Submissions Report

Bass Point Quarry Modification 3

PA 08_0143

An updated version of Figure 4 from the *Modification Report* clearly presenting contour levels, a comparison of approved and unapproved amenity barriers, approved and unapproved rehabilitation areas and areas where construction is proposed to continue is presented as **Figure 1**.

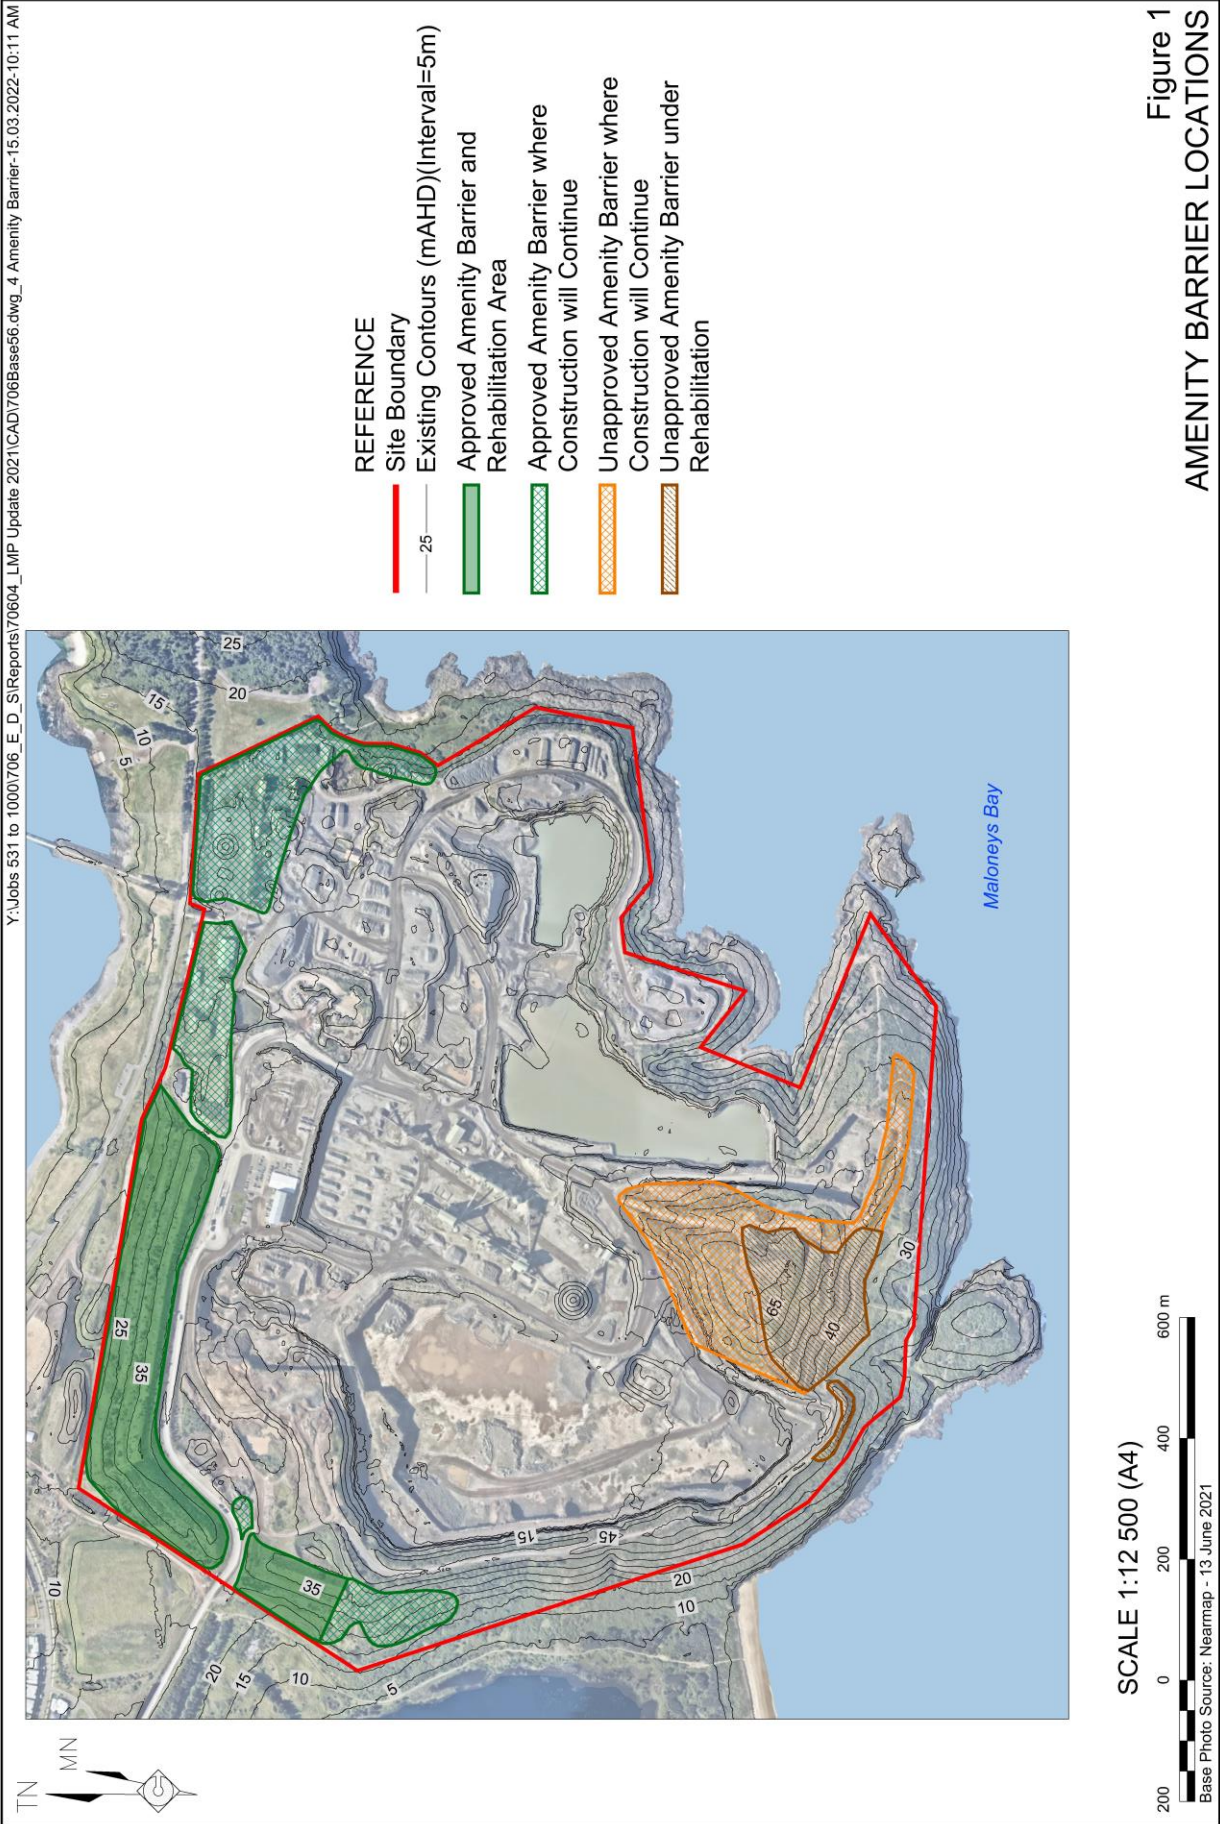
- *Amended plans which clearly show the existing and proposed contour levels across the areas the subject of this modification (note that the submitted plans are not provided at a resolution which allows for the reading of the contour lines).*

- *Amended plans which clearly identify what amenity barriers exist on the site currently, what additional amenity barriers (or additional height to be added to existing barriers) are proposed to be constructed at the site and what parts, if any, of the existing amenity barriers have current development consent.*

- *Additional information which clarifies whether the screen mounds noted on the 'Approved Quarry Layout Plan' as being 30m AHD and 40m AHD along the northern boundary of the quarry are existing and have been constructed to the approved heights.*

- *Amended plans which clearly identify what rehabilitation areas have development consent and which are proposed as part of the modification request.*

...The visual amenities to be modified or constructed are not clearly detailed in the modification proposal. I am requesting the approval document to be revised to include a diagram that clearly shows existing visual amenities vs the proposed visual amenities, the diagram needs to allow the general public to understand the locations where the visual amenities will be constructed or modified.

It is proposed that imported material would be used for amenity barrier construction as shown in **Figure 1**. Following completion of the amenity barriers, these areas will be rehabilitated in accordance with the approved *Landscape Management Plan*. This notwithstanding, imported materials may be used for both amenity barrier construction and rehabilitation generally within the Quarry Site.
